MODEL	No.	DATE
D - 1 1 0	Service Information No.	1990-07-10 100418B

VERSION LIST(VER.1.08->VER.1.13)

◇PROGRAM ROM (IC19 ON MAIN BOARD)

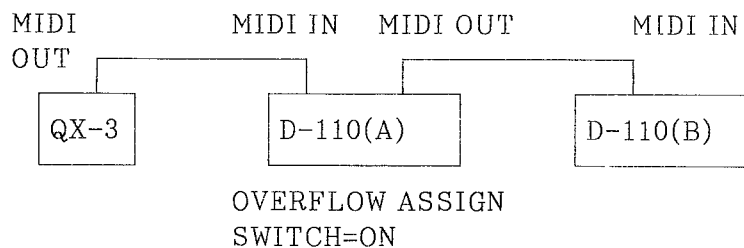
\*IN COMBINATION USE OF D-110 AND YAMAHA QX-5FD, WHEN YOU PRESSED THE STOP BUTTON OF QX-5FD DURING THE SEQUENCE PLAYING , D-110 WILL BE STILL SOUNDING IN SOME NOTES. BUT SUCH A PROBLEM SELDOM OCCURS.

IN 3 BYTES TYPE MIDI MESSAGE, THIS PROBLEM WILL BE OCCURRED. TO BE CONCRETE, WHEN "FC(STOP)" MESSAGE BROKEN BETWEEN THE SECOND BYTE AND THE 3RD BYTE OF "NOTE ON EVENT", THIS NOTE WILL NOT TURN OFF BY THE ABOVE "FC" MESSAGE, SO THIS PROBLEM DEPENDS ON THE TIMING PRESSING THE "STOP" BUTTON ON QX-5FD.

THIS PROBLEM NEVER HAPPEN WITH ROLAND SEQUENCER. BECAUSE ROLAND SEQUENCER WILL SEND "ALL NOTE OFF" MESSAGE TO PREVENT THIS KIND OF PROBLEM.
